UNC Charlotte Phase 16

Addendum #4

Revision Narrative

2021-09-08

Jenkins • Peer Architects © copyright 2021
ELECTRICAL DETAILS AND GENERAL PROJECT NOTES

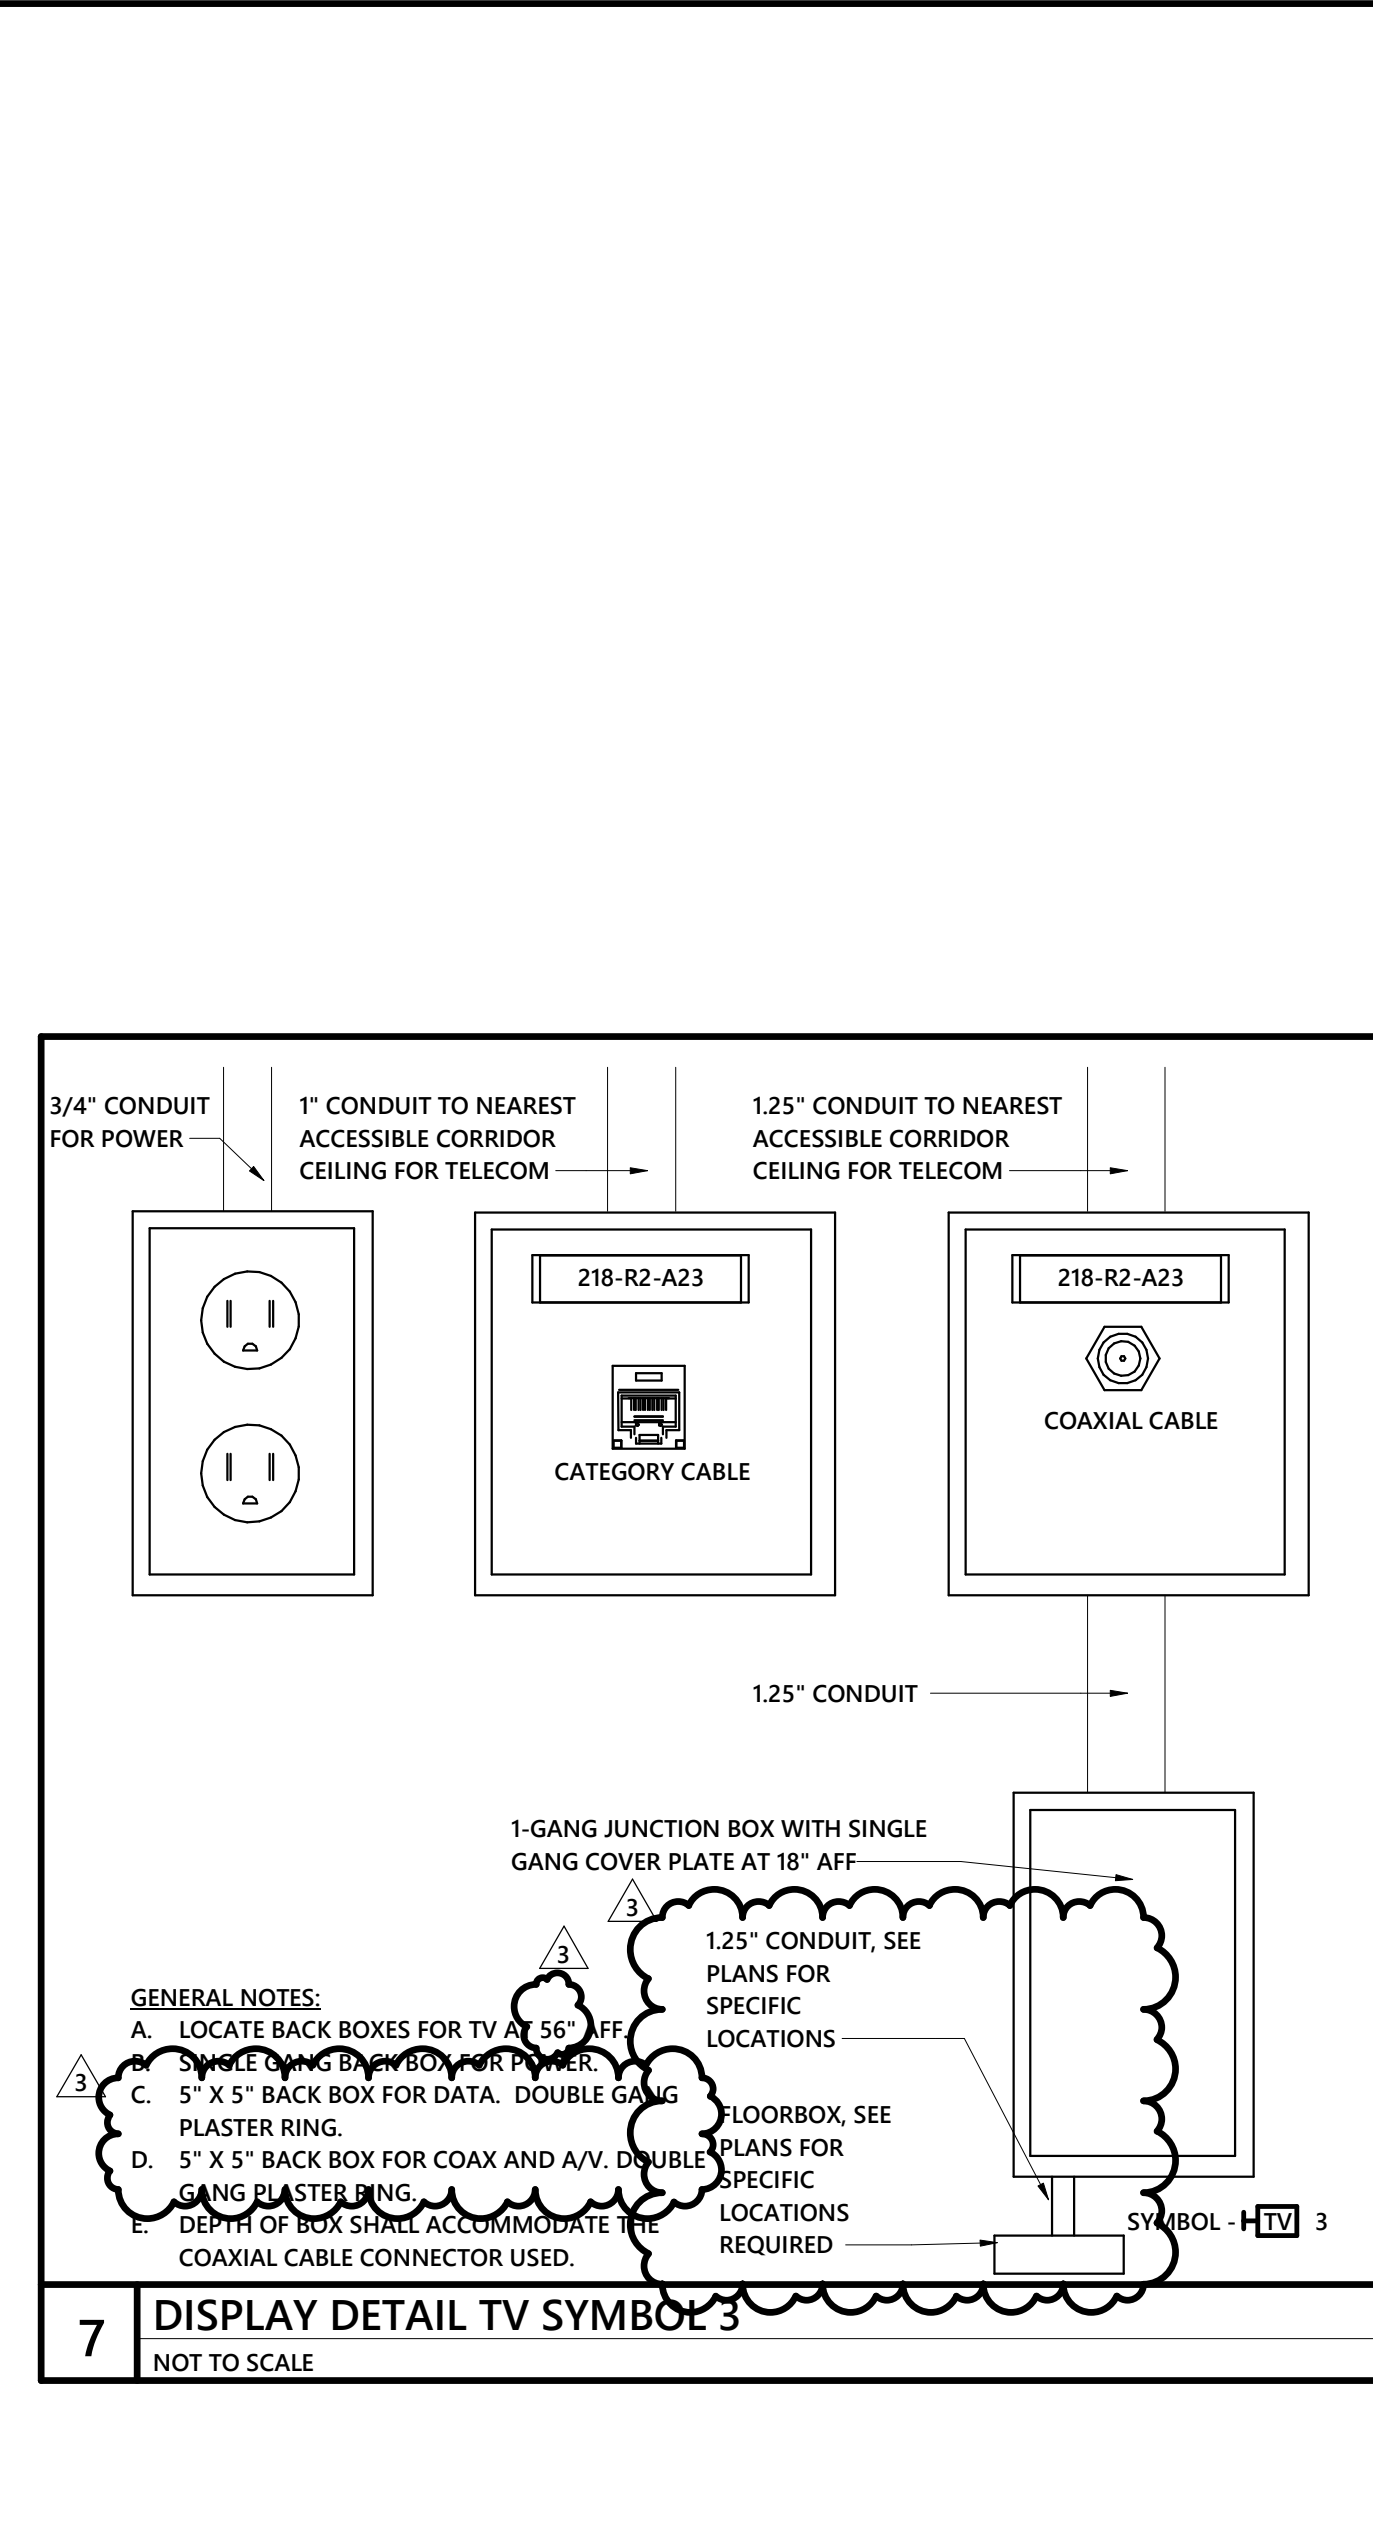
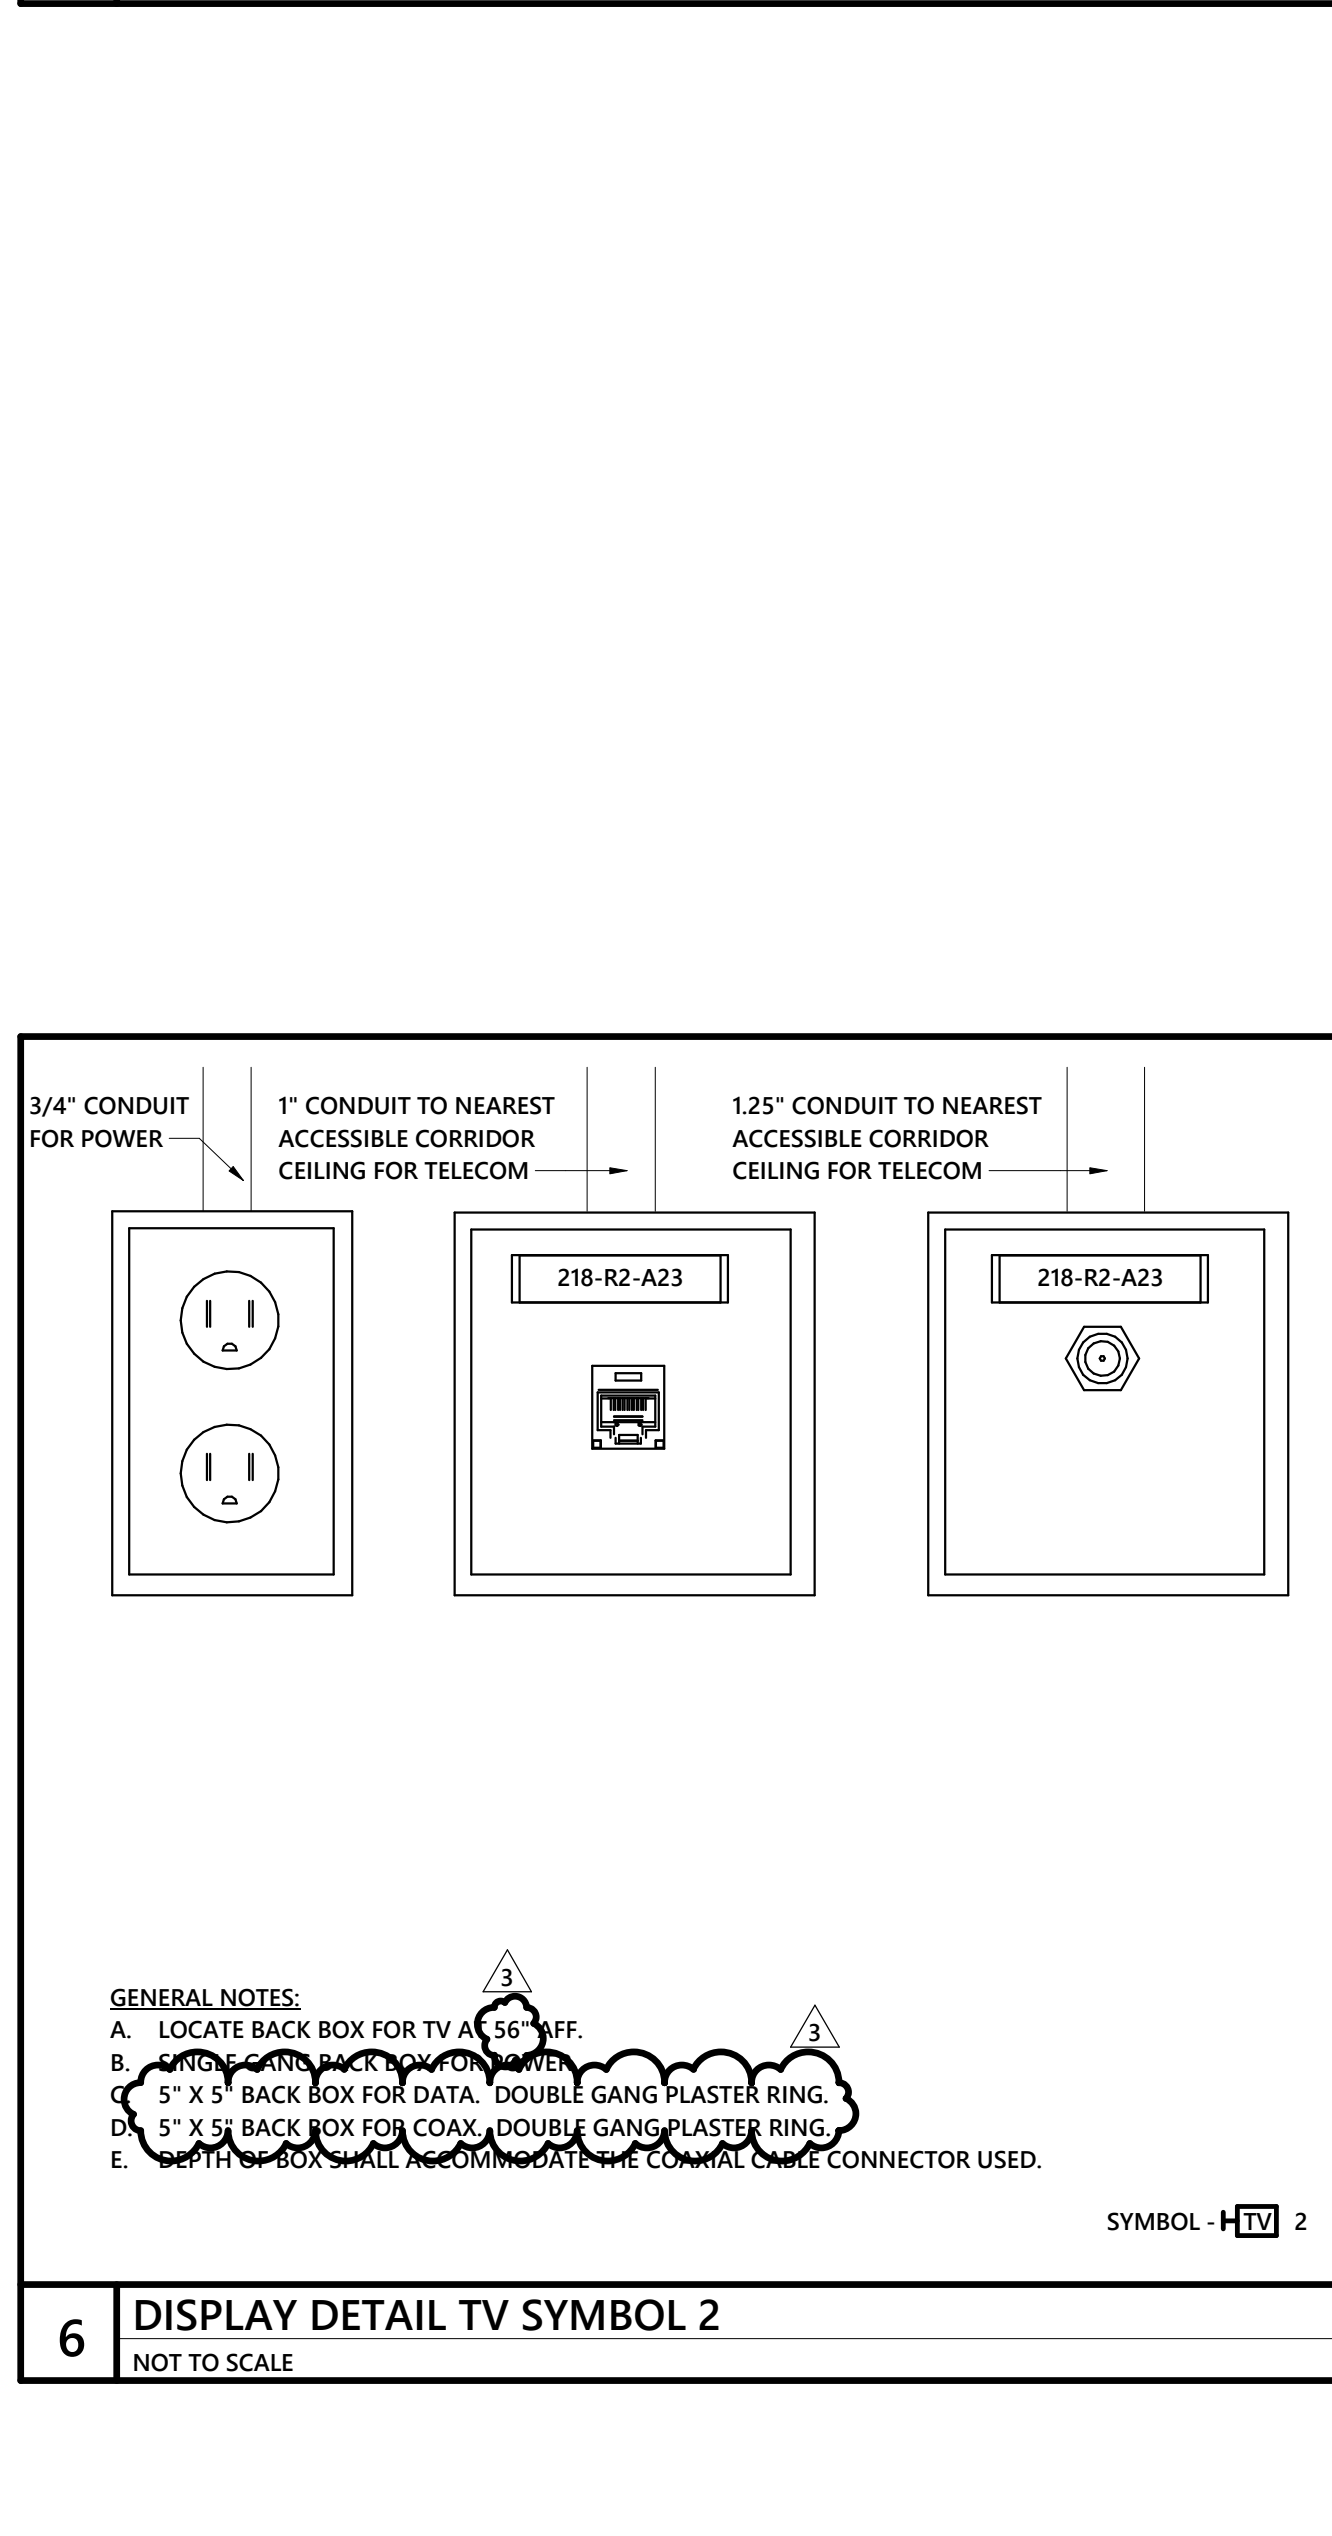
E-009 - detail #9 updated (TV 5). Detail #7 updated (TV 3). Detail #8 updated (TV 4). Detail #6 updated (TV 2).

Rooms affected by #7: LOUNGE 050, Lounge 036, CONFERENCE 151, LOUNGE 254, LOUNGE 354, LOUNGE 454

Rooms affected by #9: STUDY 030, STUDY 110, STUDY 130, STUDY 136, STUDY 210, STUDY 230, STUDY 289, STUDY 310, STUDY 330, STUDY 389, STUDY 410, STUDY 430, STUDY 489, STUDY 510, STUDY 530, STUDY 589.

Rooms affected by #8: CLASSROOM 055

Rooms affected by #6: LOBBY COR008
